CYLON® TECHNICAL BULLETIN NO. 528
 Issue Date: 14 December 2023

CXpro^{HD} v1.07.03

Introducing new CXpro^{HD} strategy modules and fixed outstanding issues.

BACnet Binary Priority Writer module

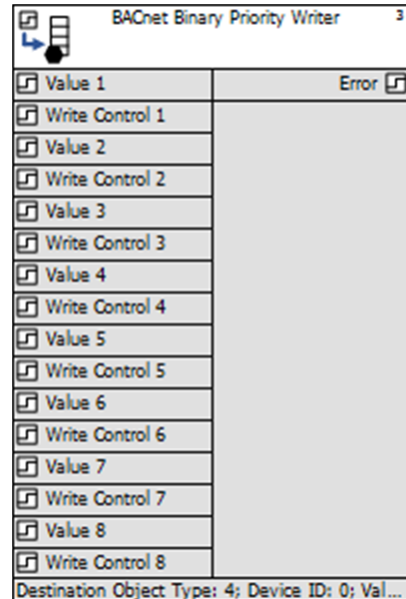
The BACnet Binary Priority Writer module controls different priority levels of a binary BACnet value or output.

A priority level is controlled by the Value input, the Write Control input, and the priority level constant. The Value input is applied to that level of the priority array when the Write Control input is high. You can set any value of any level from 1 to 16 in the priority array or disable it by setting the priority to "Not Configured".

The priority array for the binary value or binary output is viewable through BACnet. In addition, the following two properties are provided to show what is being written.

Property 50001 will display if an override in the priority array is in effect. If the current commanded priority is between 1...15, this value will be true, otherwise it is false.
